Illinois Department of Transportation

Memorandum

To: ALL BRIDGE DESIGNERS 19.3
From: D. Carl Puzey *D. Carl Puzey*
Subject: Revised provisions for Precast Prestressed Concrete IL
Beams and applicable I and Bulb T Beams
Date: March 25, 2019

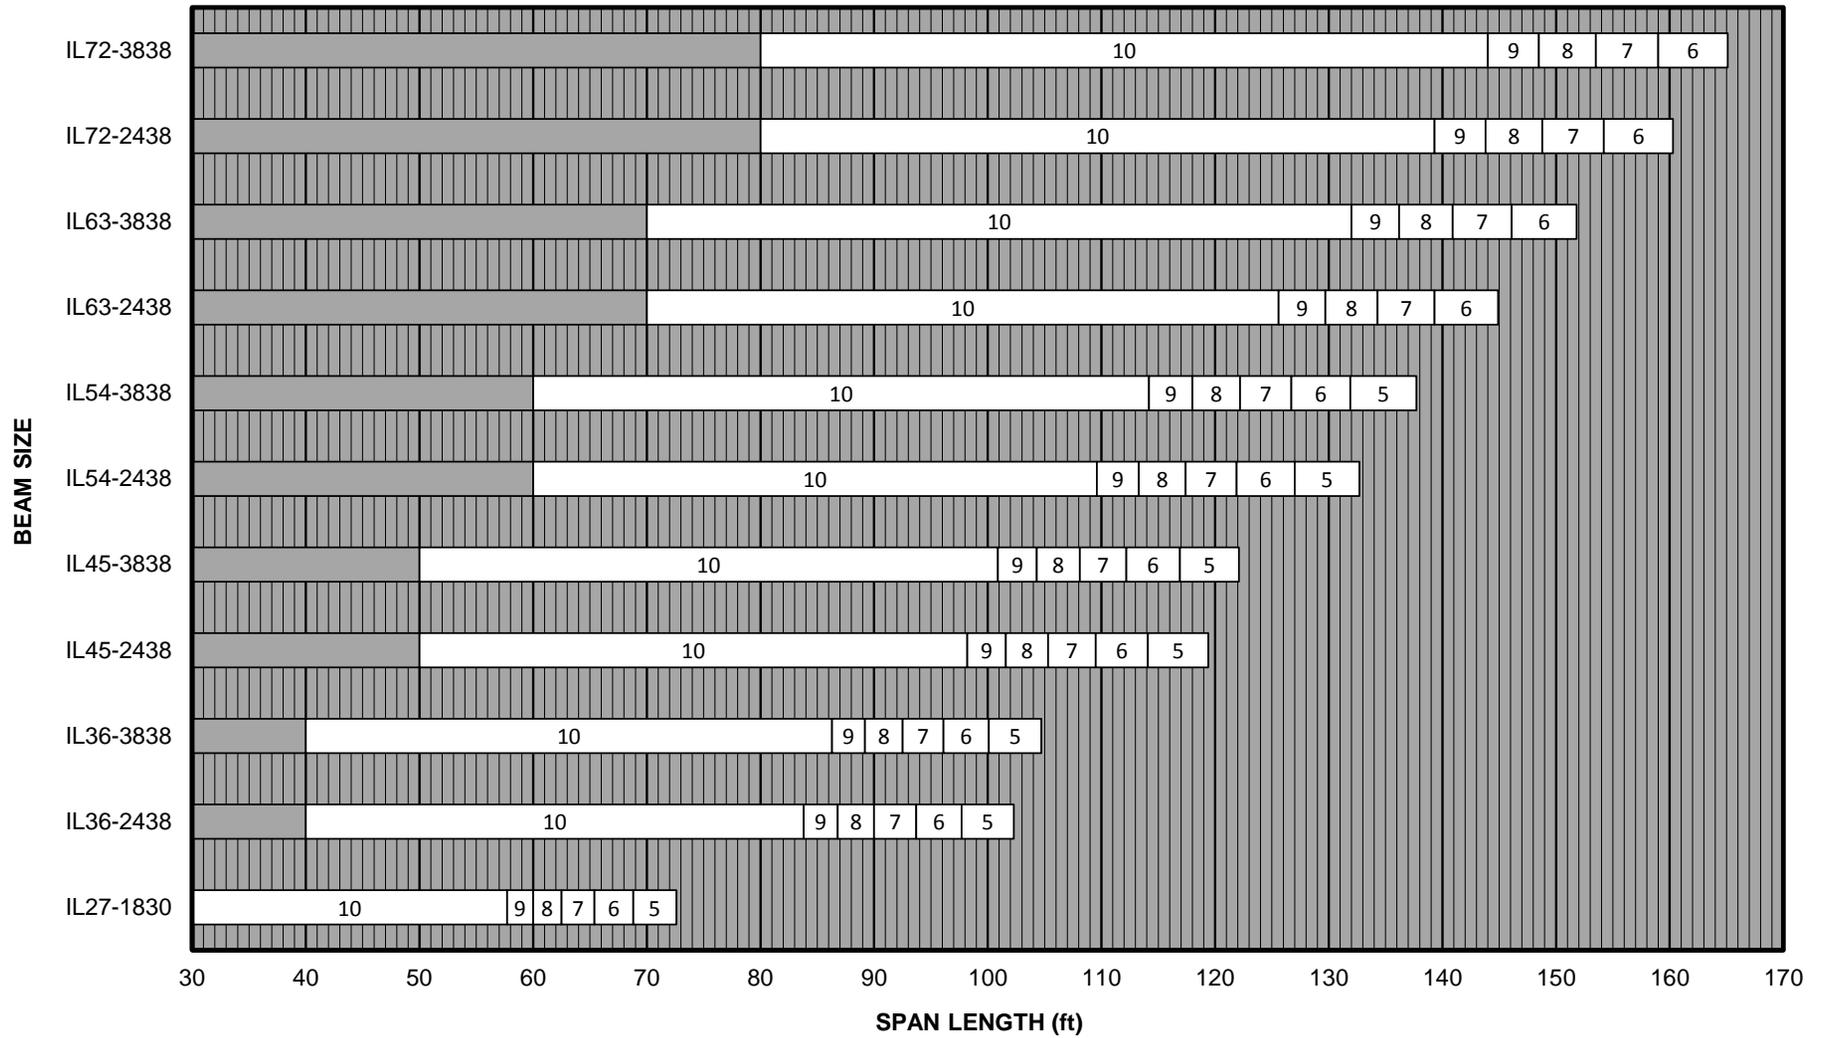
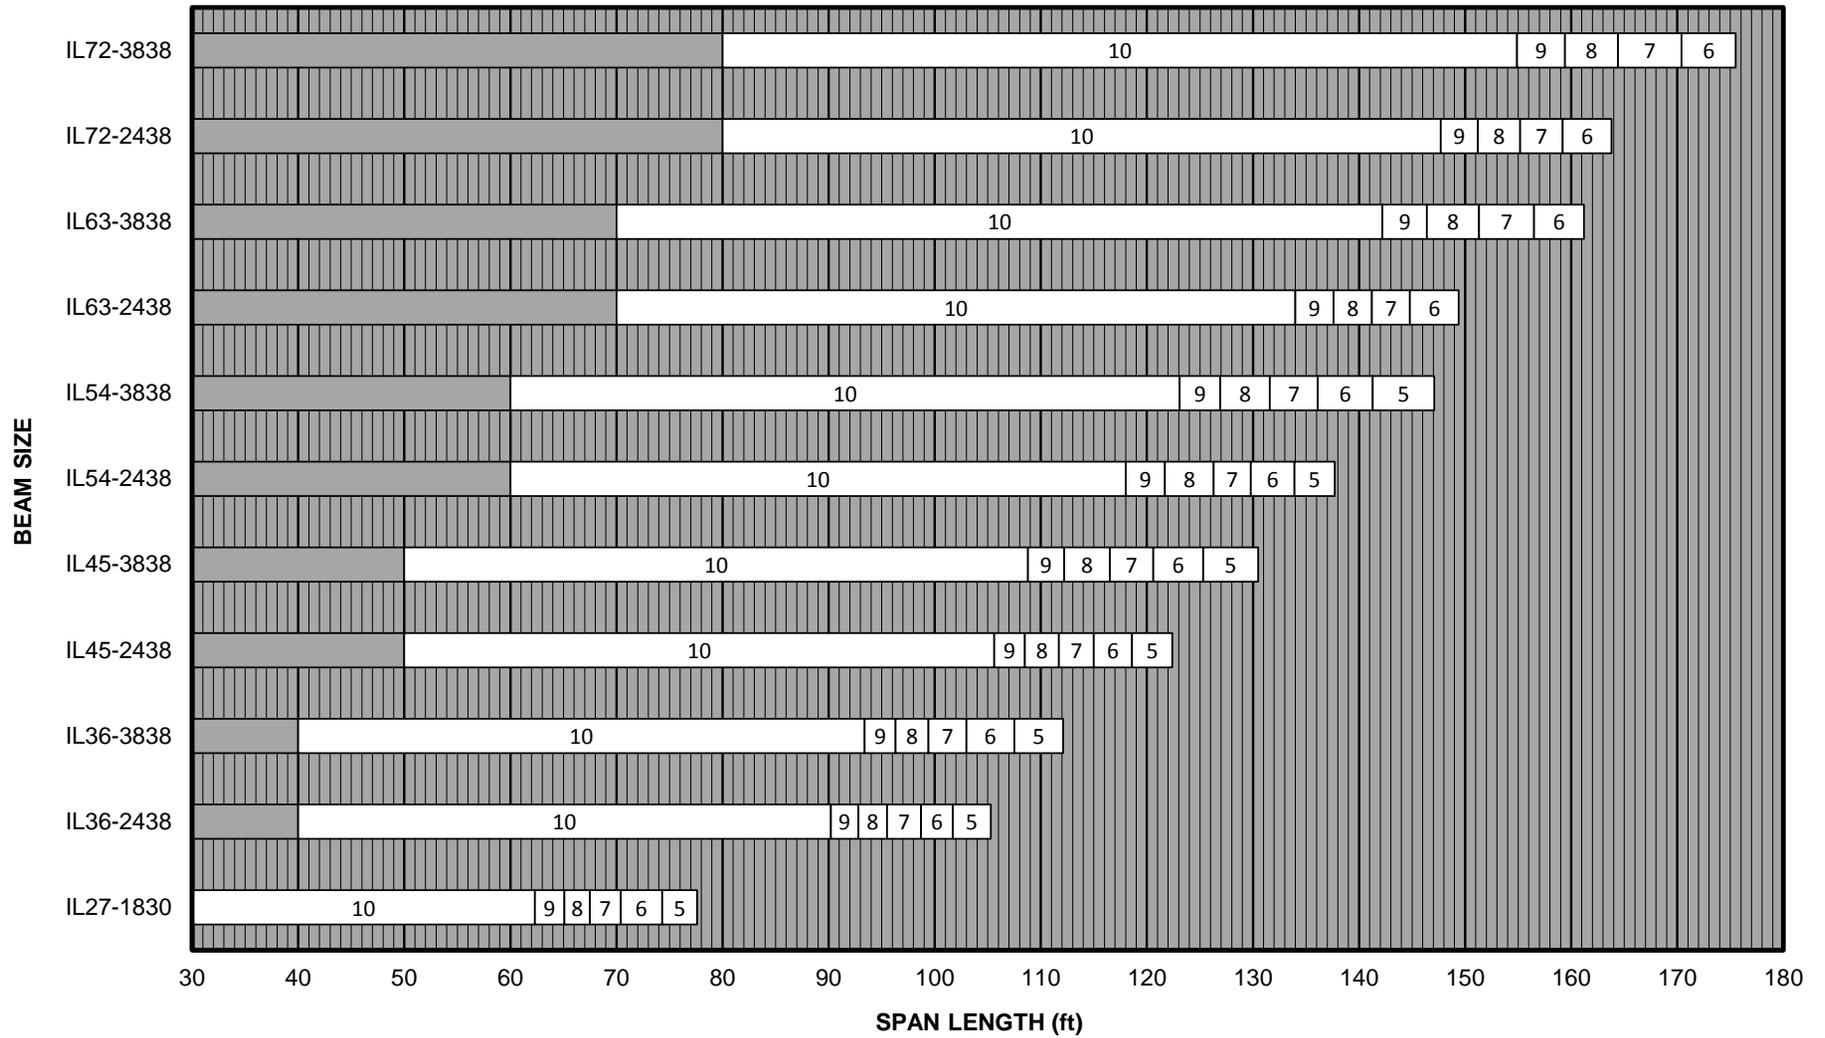
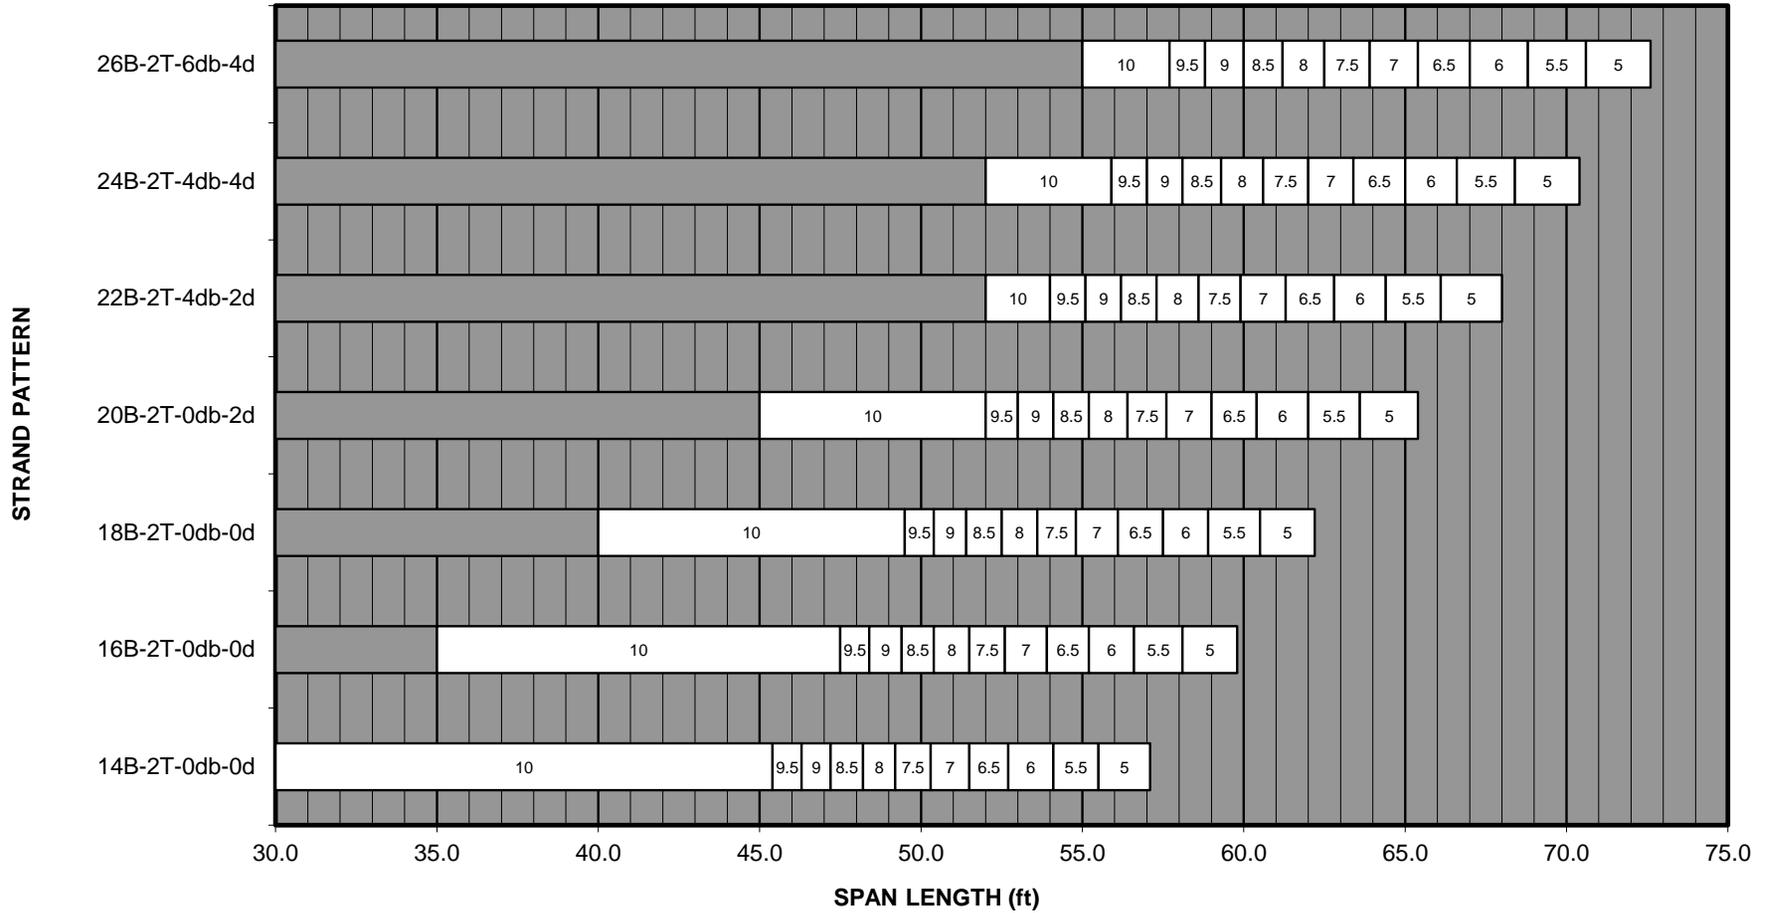
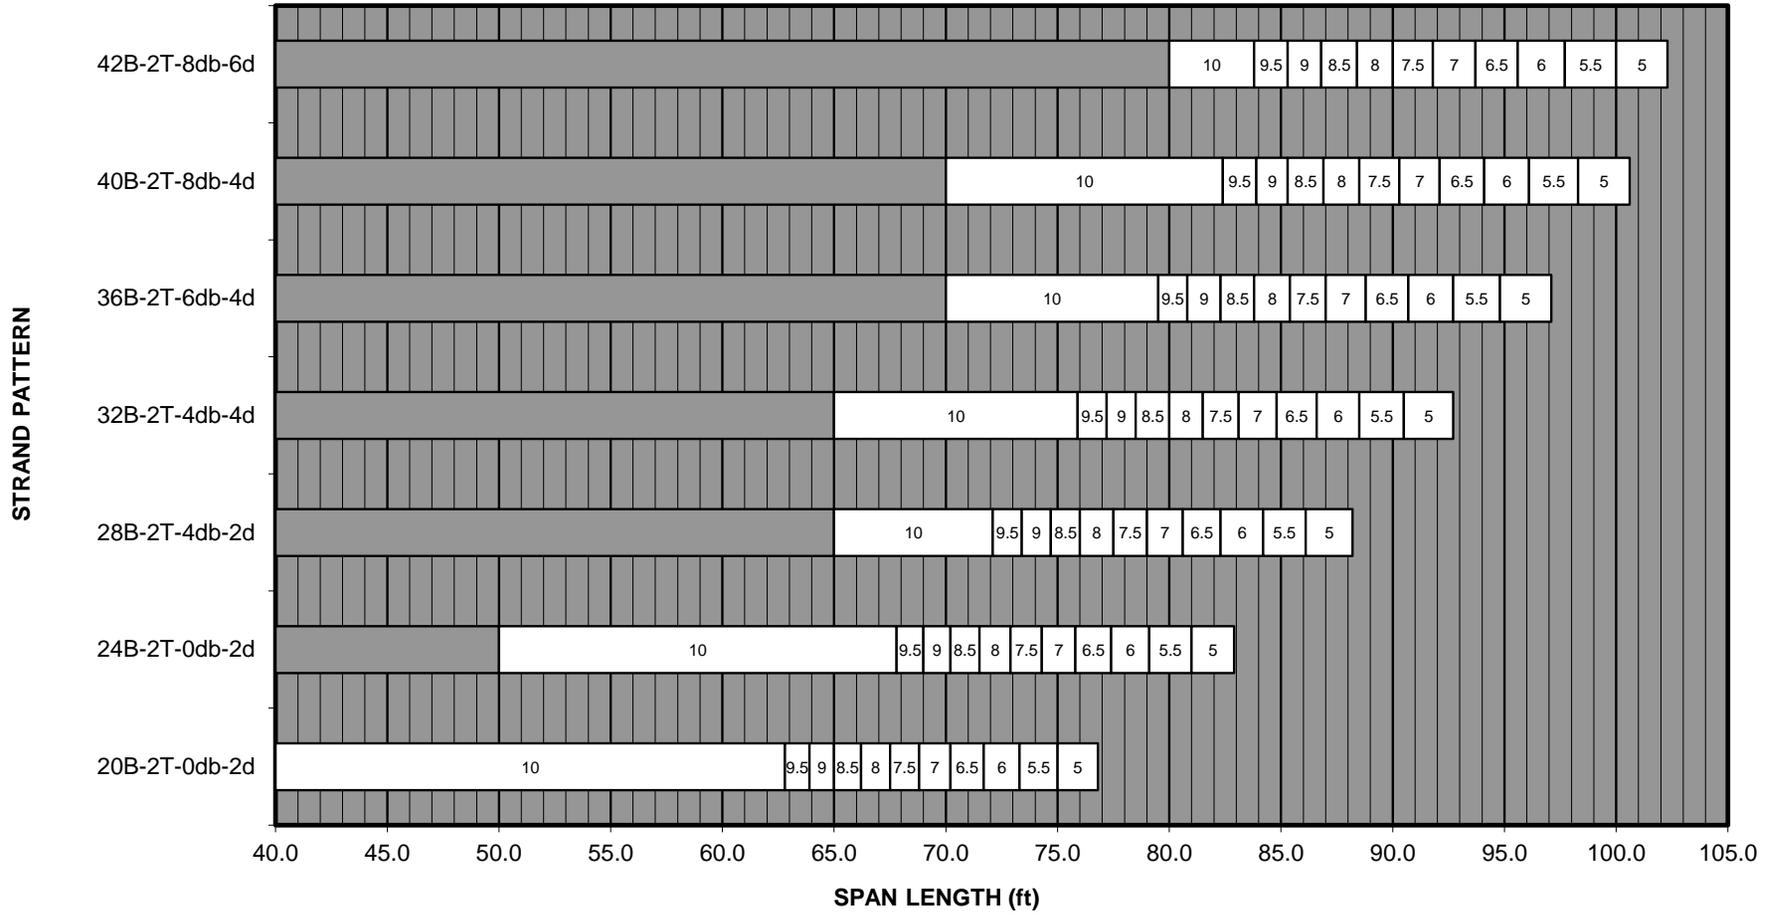
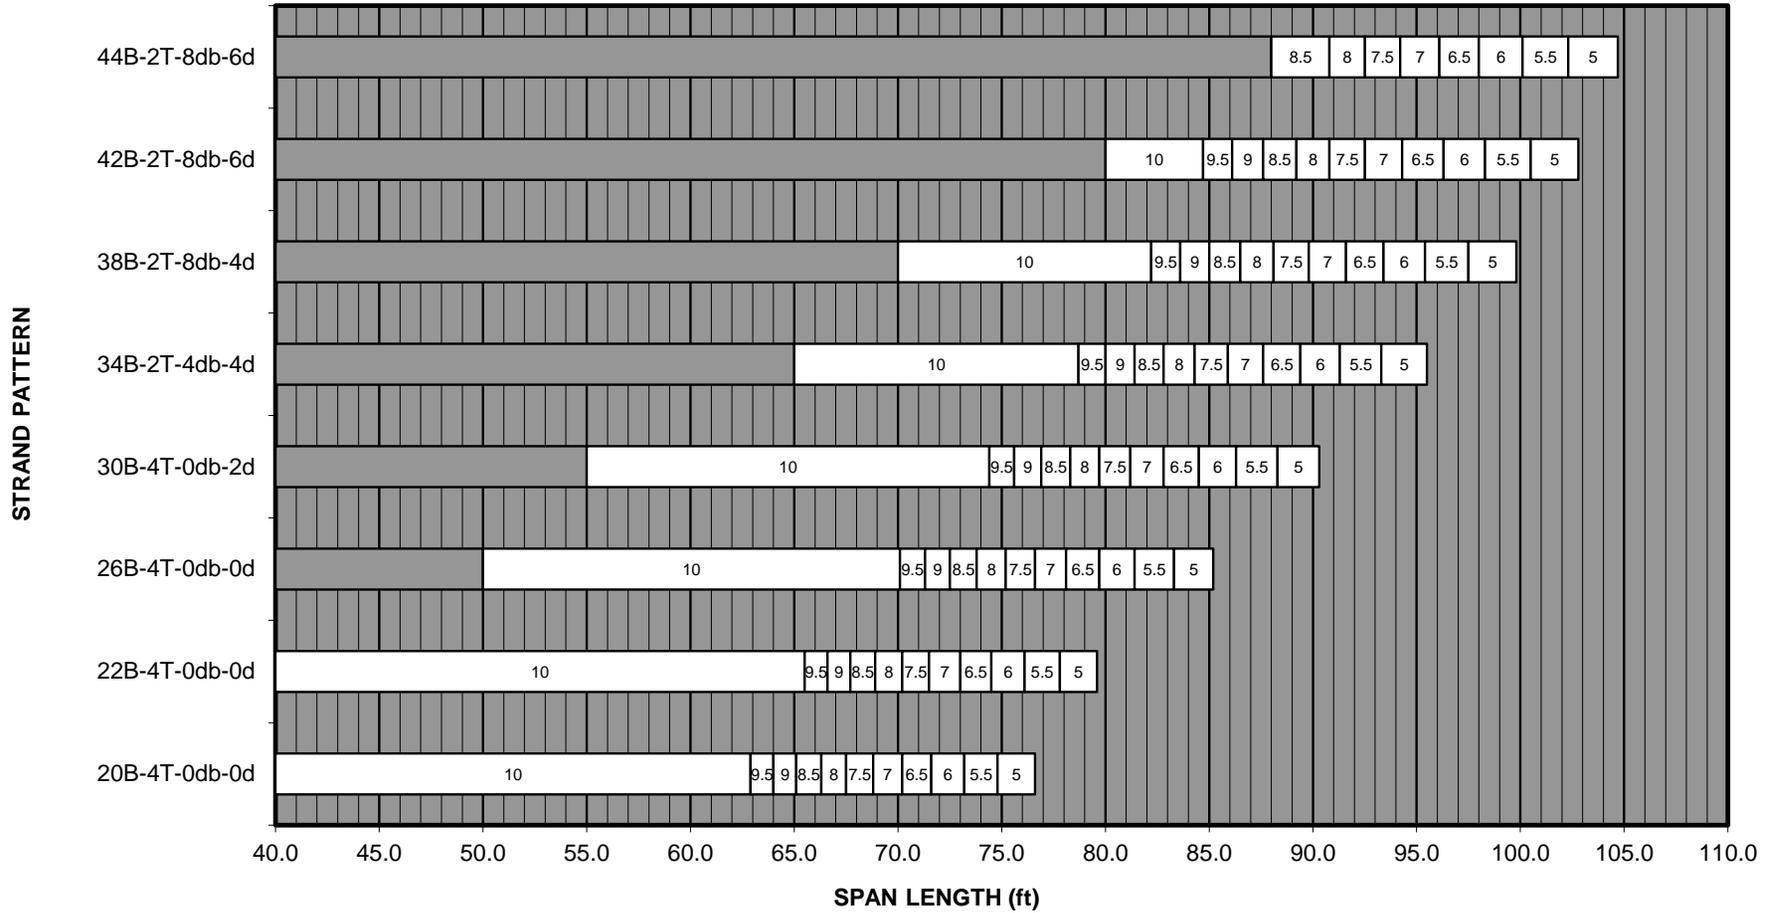
The Department evaluated our standard strand patterns and beam configurations for an f'_c of 6.5 ksi and found that the allowable span length for each beam depth would be reduced by an amount less than two feet. Therefore, the IL-Beam base

sheets have been updated to allow a concrete release strength of 6.5 ksi instead of 7.0 ksi and the Planning Charts, Figures 4 through 16 of ABD memorandum 15.2, have been updated with slightly reduced permissible span lengths. These charts are included in this memorandum.
